From: John Smith <john.smith@mewbourne.com>
Sent: Friday, May 23, 2025 3:48 PM
To: Gomez, Matthew, EMNRD <Matthew.Gomez@emnrd.nm.gov>; Rikala, Ward, EMNRD
<Ward.Rikala@emnrd.nm.gov>; McClure, Dean, EMNRD <Dean.McClure@emnrd.nm.gov>
Cc: Bradley Bishop <bbishop@mewbourne.com>
Subject: [EXTERNAL] Stone Cold 23/14 Fed Com #528H Sundries

Received by 10 CD. S 23/2025 4:18:51 PM		Sundry Print Report
U.S. Department of the Interior BUREAU OF LAND MANAGEMENT		05/23/2025
Well Name: STONE COLD 23/14 FED COM	Well Location: T18S / R33E / SEC 26 / NENE / 32.7248073 / -103.6279546	County or Parish/State: LEA / NM
Well Number: 528H	Type of Well: OIL WELL	Allottee or Tribe Name:
Lease Number: NMNM04591	Unit or CA Name:	Unit or CA Number:
US Well Number: 3002554576	Operator: MEWBOURNE OIL COMPANY

Procedure Description: Mewbourne Oil Company request that the following change be made to the Stone Cold 23/14 Fed Com #528H (API #30-025-54576): 1. Change well name f/ Stone Cold 23/14 Fed Com #528H to Stone Cold 23/14 Fed Com #528Y. 2. Attached is updated C-102.

Procedure Description: Mewbourne Oil Company request that the following change be made to the Stone Cold 23/14 Fed Com #528H (API #30-025-5457

Stone_Cold_23_14_Fed_Com_528Y_C102__New__20250523151945.pdf

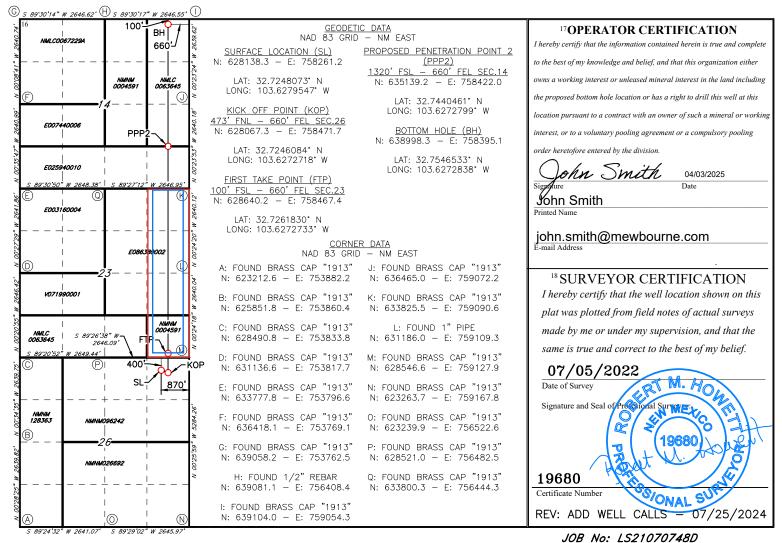
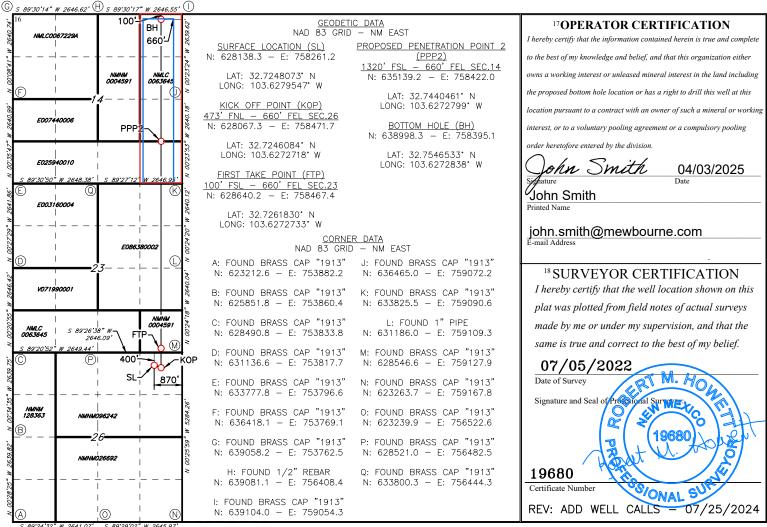
- 1. Change well name f/ Stone Cold 23/14 Fed Com #528H to Stone Cold 23/14 Fed Com #528Y.
- 2. Attached is updated C-102.

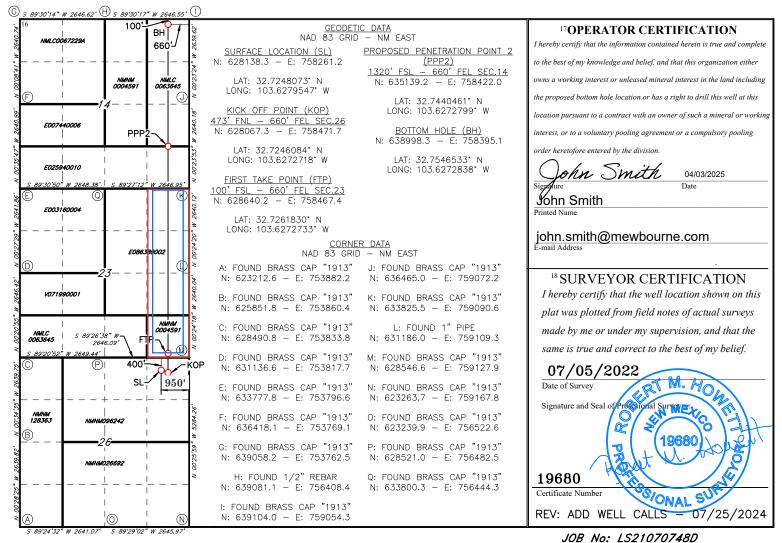
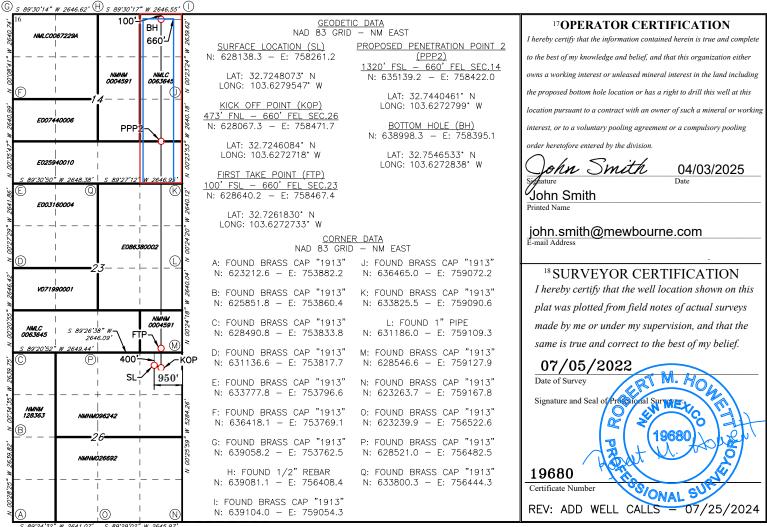
Once well is completely capped, walk rig over 80' to the west, putting SHL @ 400' FNL & 950' FEL. We will sundry well to redrill.

- 1. Request to skid original wellbore, Stone Cold 23/14 Fed Com #528H f/ 400' FNL & 870' FEL, Sec 26, T18S R33E, Lea Co., NM to 400' FNL & 950' FEL, Sec 26, T18S R33E, Lea Co., NM.
- 2. Attached is updated C-102, Drilling Program, Dir Plan corresponding w/ new SHL
- 3. Reference Sundry ID #2854547 for P&A of Stone Cold 23/14 Fed Com #528Y (Name Change Sundry ID #2854545.

Mewbourne is granted verbal approval to proceed as proposed in the 3 attached notices of intent. All COAs on the original APD for the 30-025-54576 STONE COLD 23 14 B2PA FED COM #001H are in effect for the skidded well.
